Master Plan Amendment #2018-0001
Development Special Use Permit #2018-0008
3000 Potomac Avenue – National Industries for the Blind

Application	General Data	
Project Name: National Industries for the Blind - Potomac Yard Landbay G, Block A2	PC Hearing:	June 5, 2018
	CC Hearing:	June 23, 2018
	If approved, DSUP Expiration:	Pursuant to Zoning Ordinance, Section 11-418, Time of Validity.*
	Plan Acreage Block A2 only:	0.4395 acres (19,143 square feet)
Location: 3000 Potomac Avenue Block A, Landbay G	Zone:	CDD#10
	Previously Approved Use:	Office and Retail Uses
Applicant: National Industries for the Blind; represented by Kenneth W. Wire, Attorney	Small Area Plan:	Potomac Yard/Potomac Greens
	Historic District:	N/A
	Green Building:	Compliance with the City's Green Building Policy

1. Amend the Potomac Yard / Potomac Greens Small Area Plan chapter of the Master Plan to amend the height map for the site from 110 to 117 feet;
2. Amend DSUP #2007-0022, as amended through DSUP #2014-0028, to increase the building height and to request a parking reduction;
3. Allow a Modification to the height to street centerline ratio per Sections 6-403(A).

Graphic #2: Perspective of NIB Building looking north from Potomac Avenue.

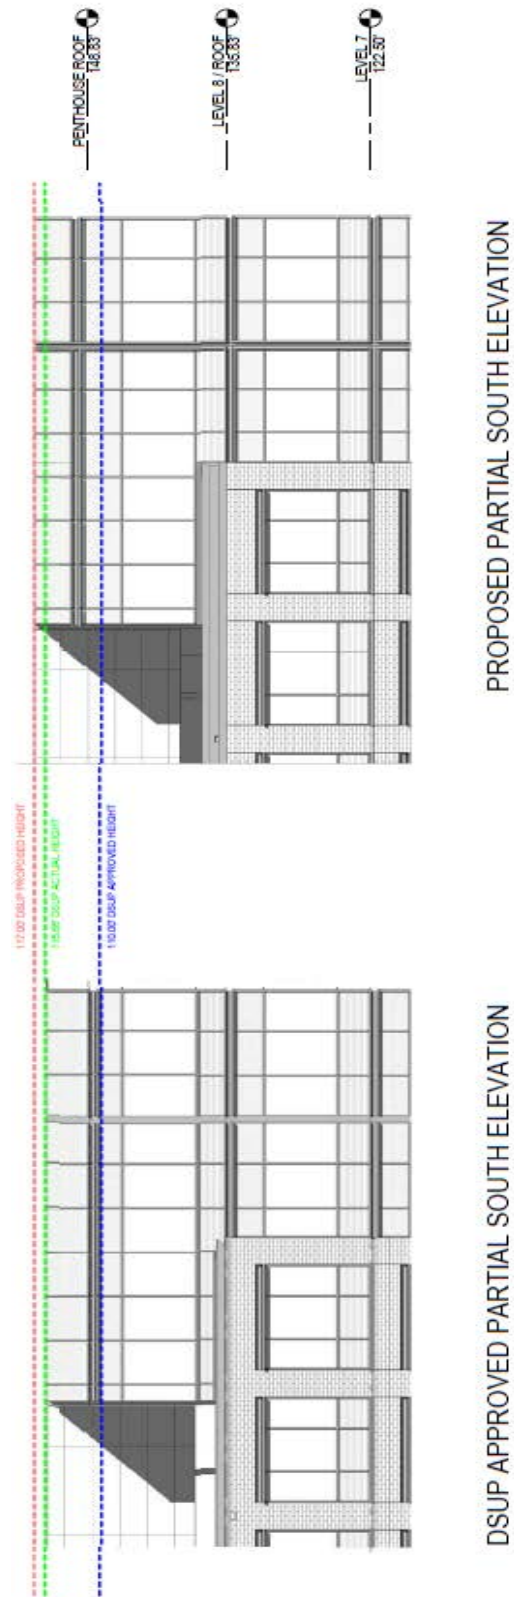
The proposed height increase of seven feet is the result of a number of circumstances, including the unexpected need to increase the height of the elevator overrun, additional space for mechanical equipment, construction error and an architectural design enhancement. These circumstances, which occurred during construction, added two additional feet to the eighth-floor board room. The other five feet resulted from a desire to increase the parapet height of the eighth floor by five feet to match the height of the mechanical penthouse. Additionally, during the final engineering of the building it was determined that the elevator overrun needed to be increased in height by a foot to 19 feet and the overall mechanical penthouse was increased in area as well to screen additional mechanical equipment that was needed for the two office tenants.

117.00' PROPOSED HEIGHT
 115.66' DSUP ACTUAL HEIGHT
 110.00' DSUP APPROVED HEIGHT

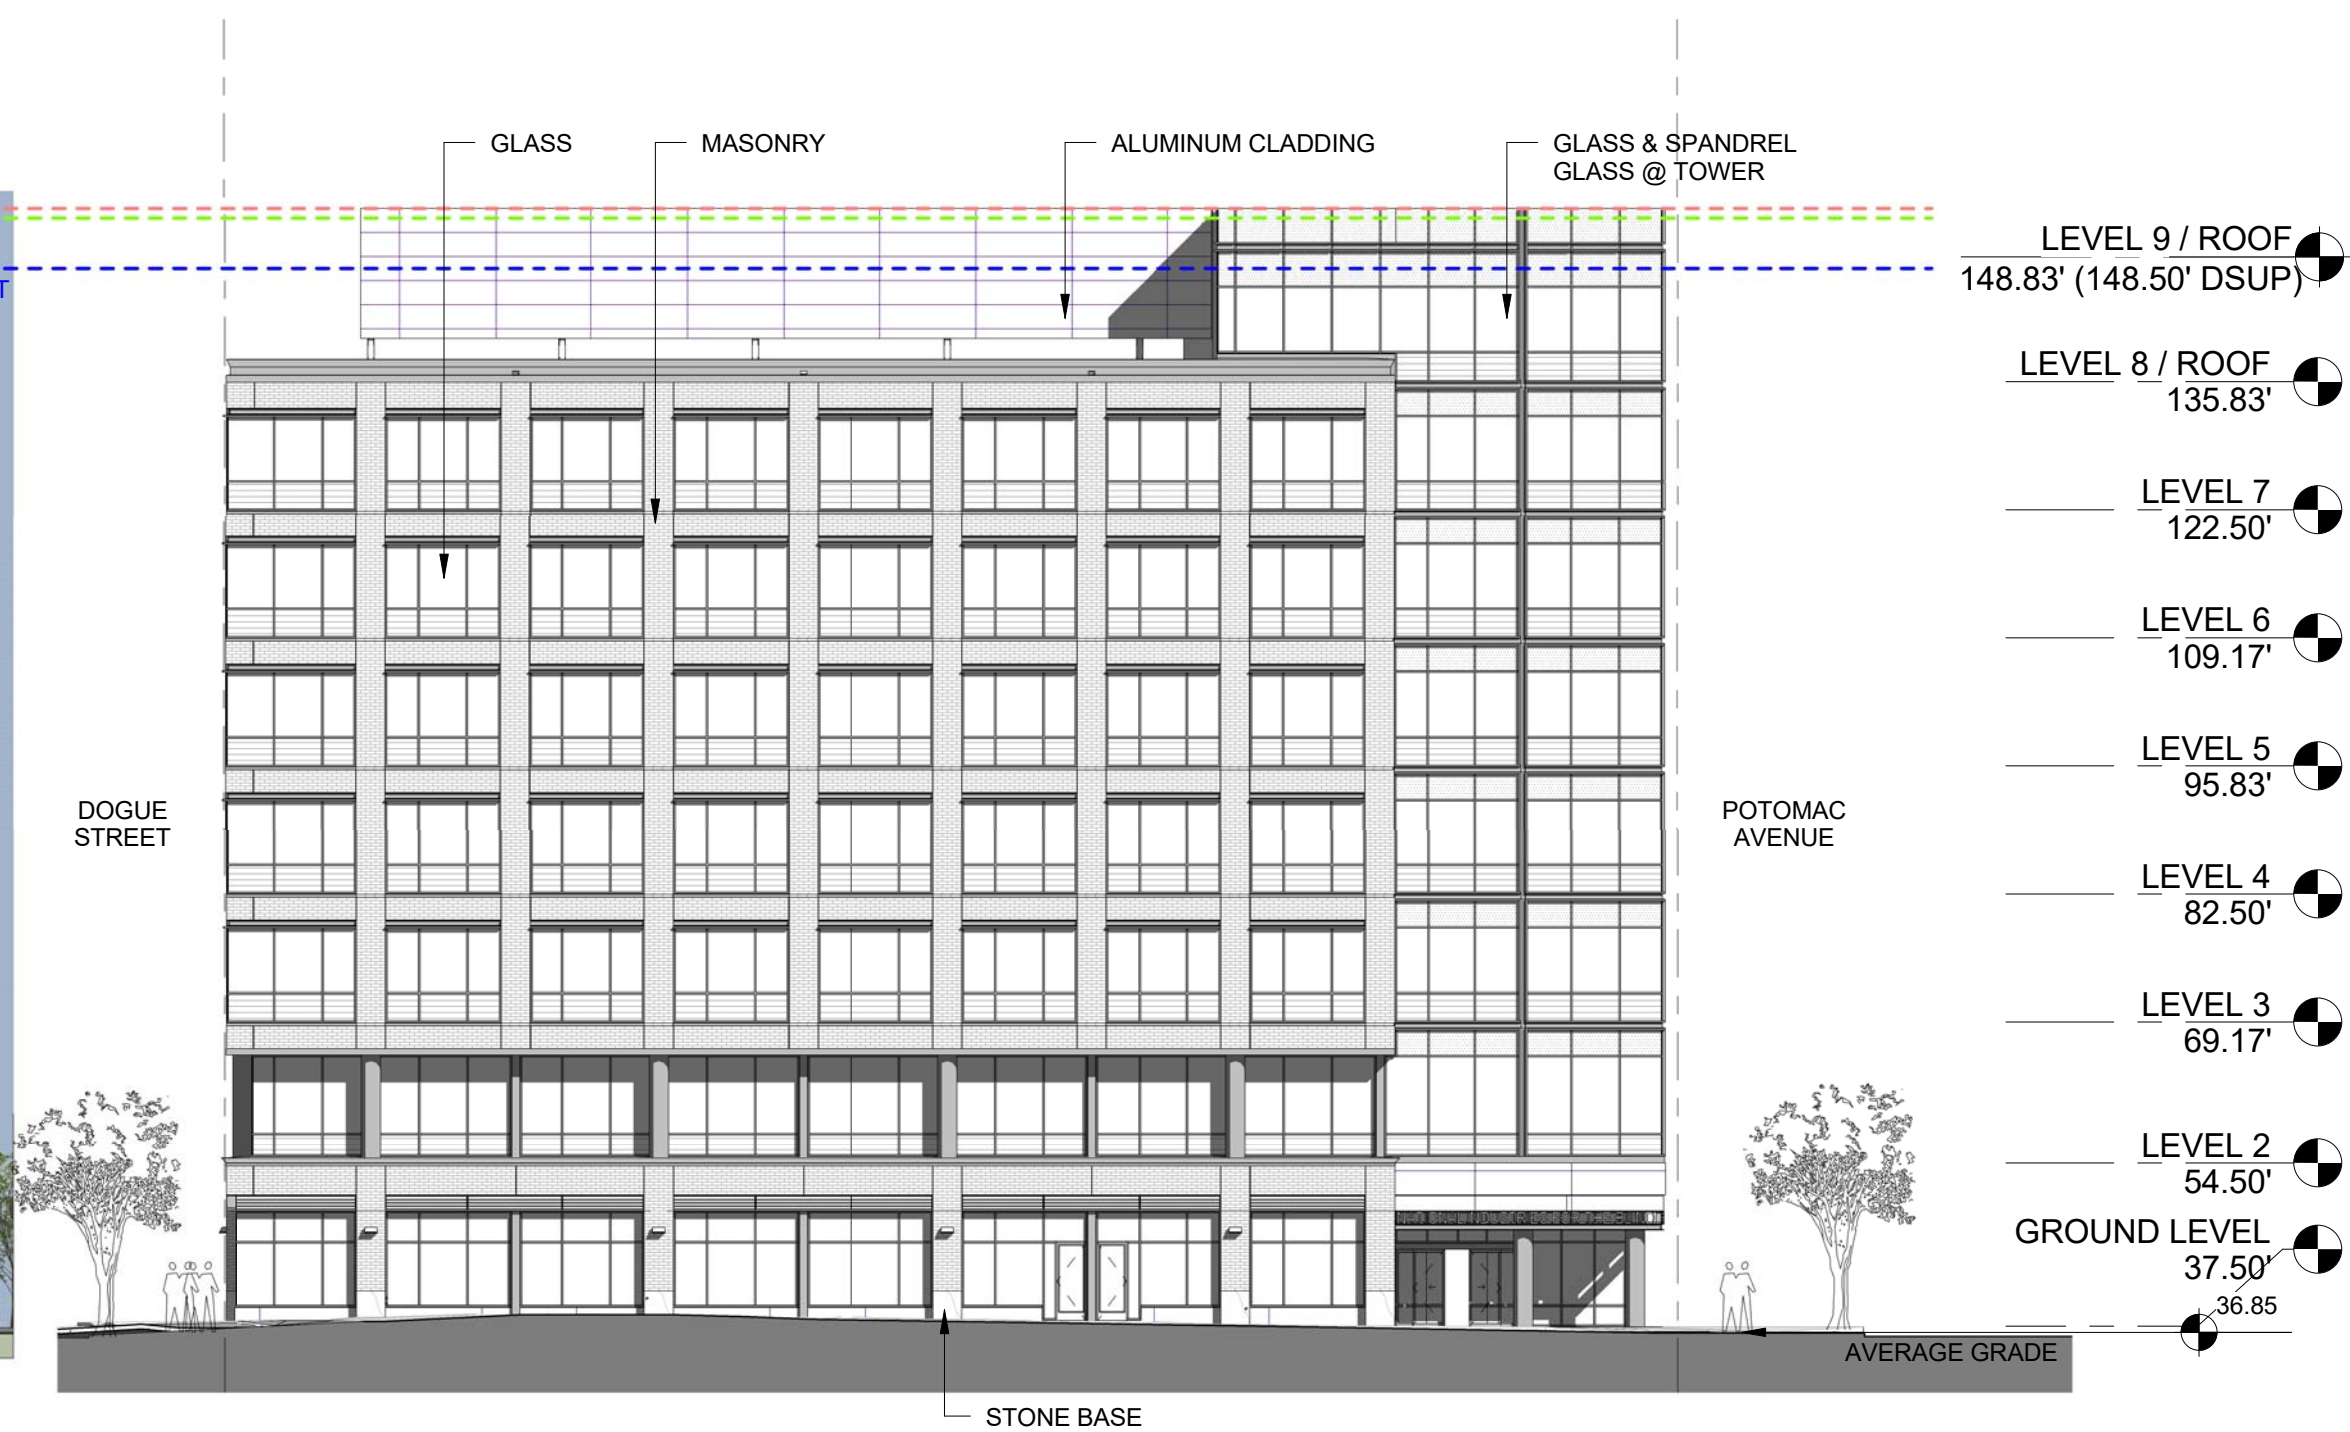
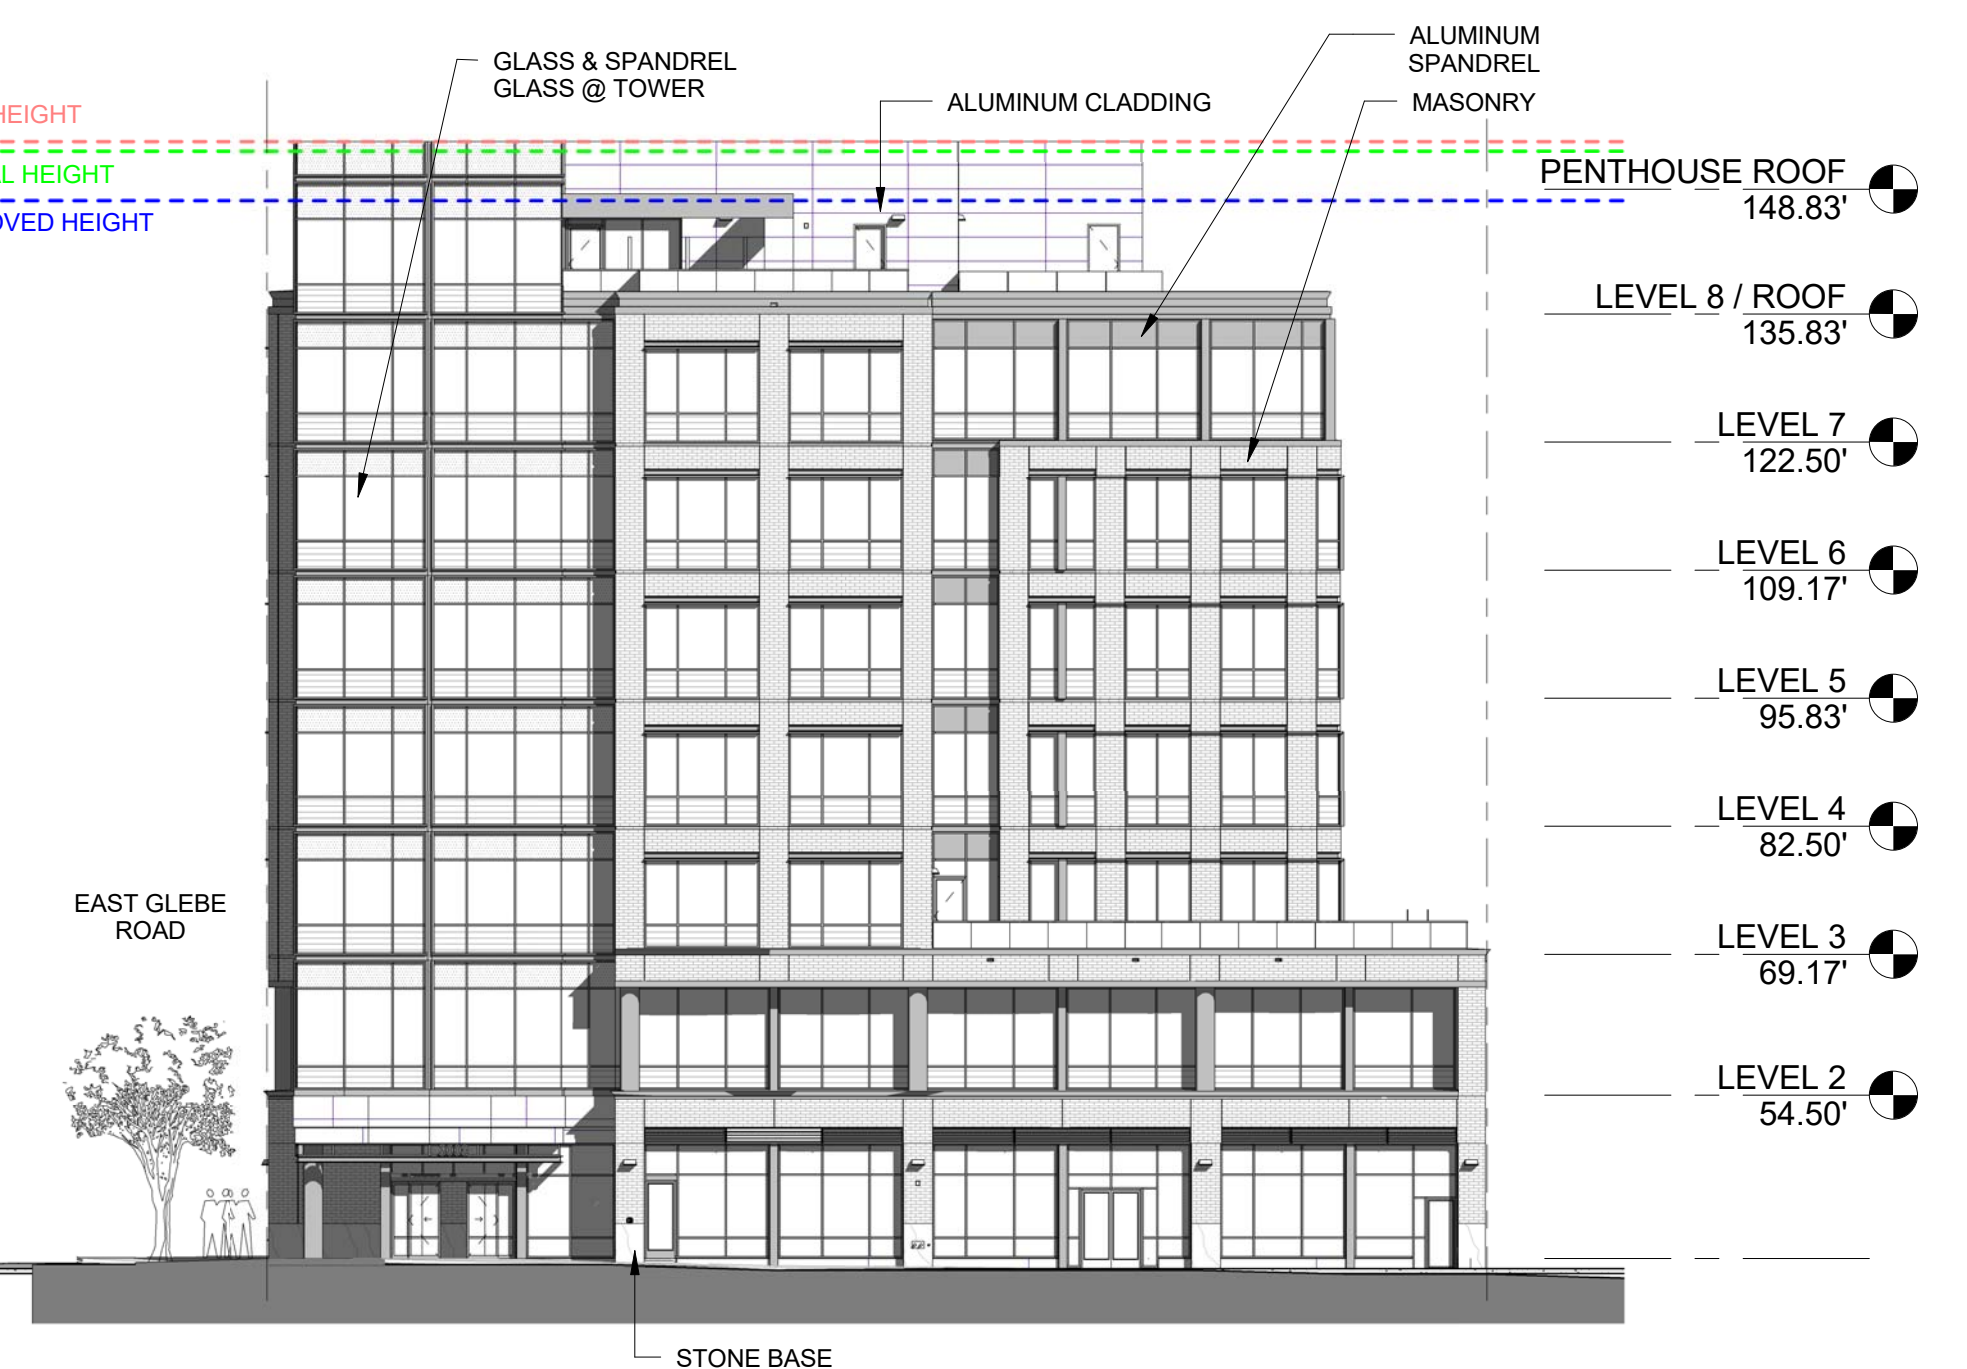
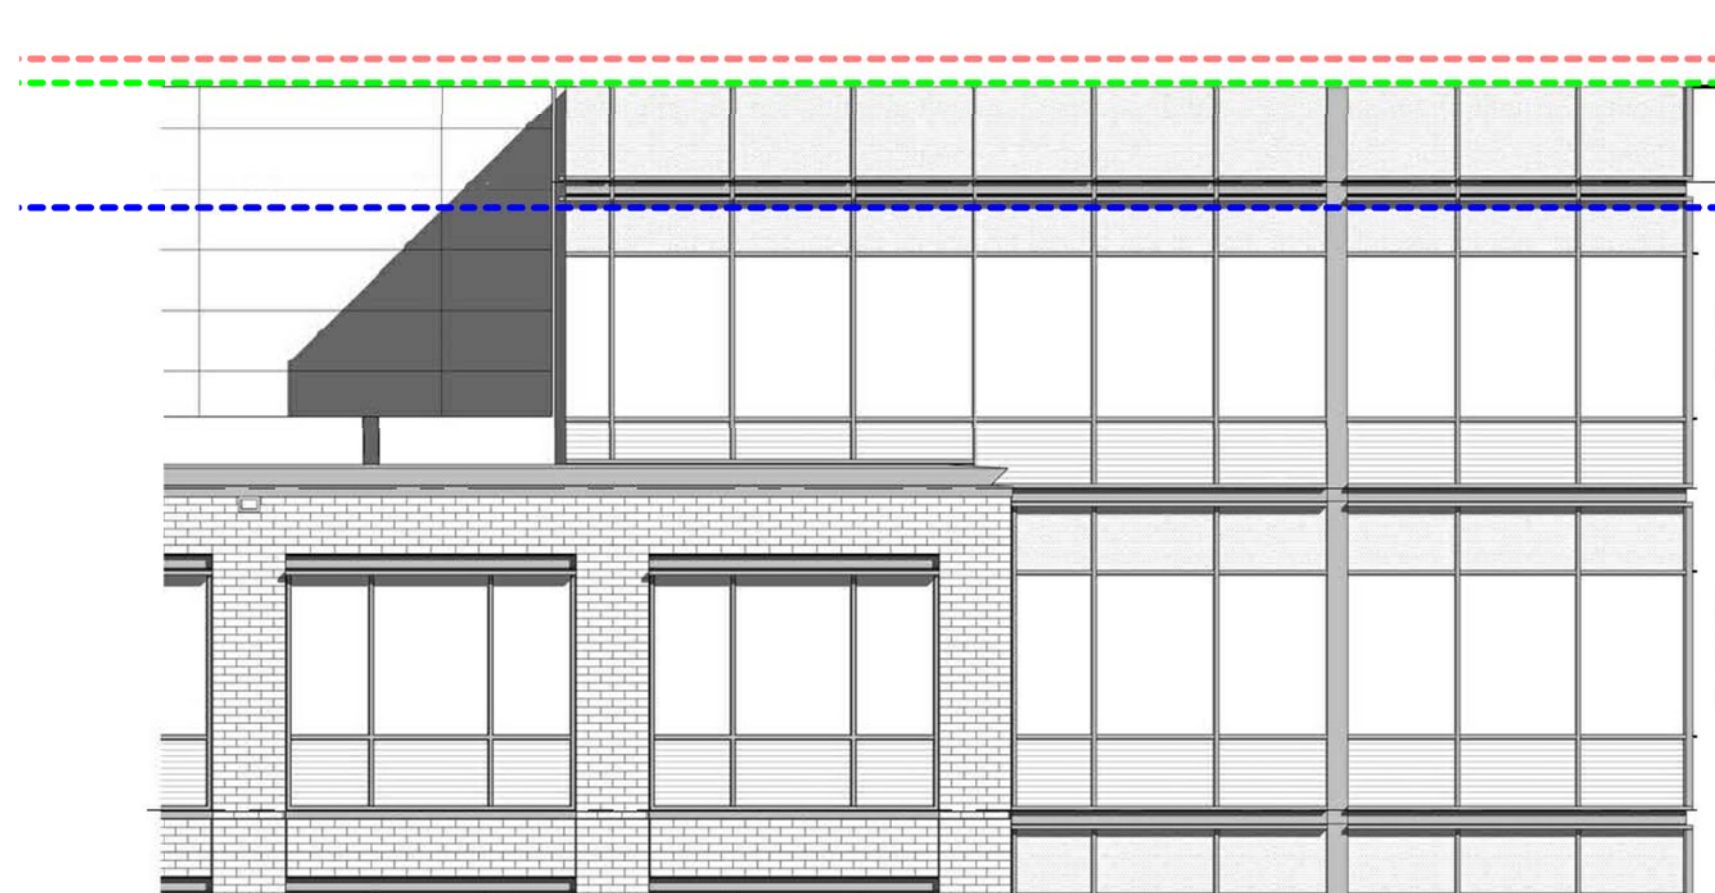
As part of this proposal, the applicant is also requesting a modification to the height-to-setback ratio requirements under Section 6-403(A) of the Zoning Ordinance which is triggered by the proposed increase in building height. The original NIB approval also included a height-to-setback ratio modification based on the 110-foot height. Section 6-403(A) states that the allowable height of a building at any point shall not exceed twice the distance from the face of the building to the centerline of the street facing such a building, in this case, Potomac Avenue, East Glebe Road and Dogue Street. Pursuant to the height-to-setback requirements of the Zoning Ordinance and the distance of the building face from the property line, the maximum height at the building face on Potomac Avenue should be 90 feet, while the maximum height at the building face on East Glebe Road should be 72 feet and Dogue Street should be 64 feet. These were the same distances as were approved with the original NIB DSUP, but the modification was granted based on a 110-foot building height, not the proposed 117 feet. Approval of the modification would address this change in height.
